Changes in the rating plate and the packaging label according to the compliance with EAC

May 2019

MELIPC series

Item	Before change	After change
Rating plate

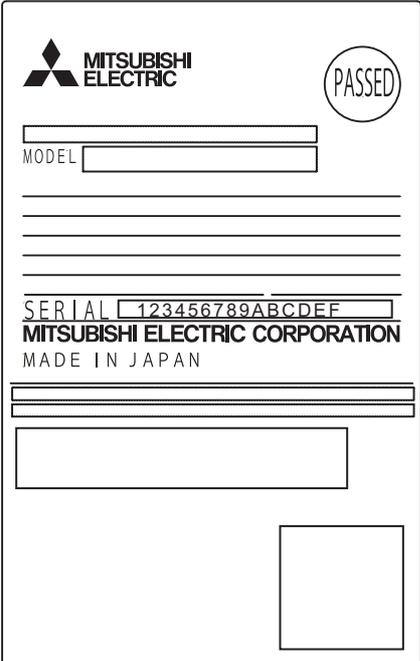
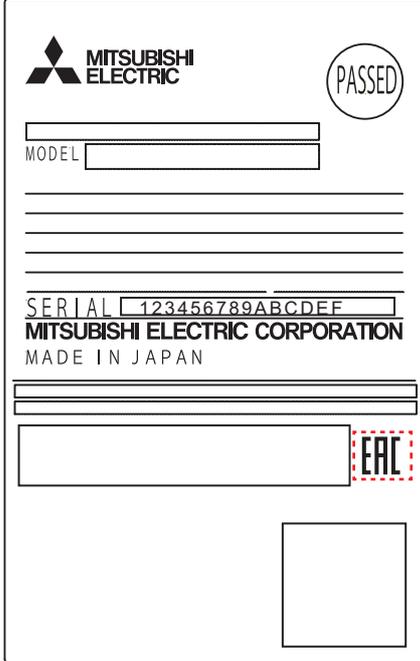
An EAC mark is added to the rating plate and packaging label for EAC certified products.
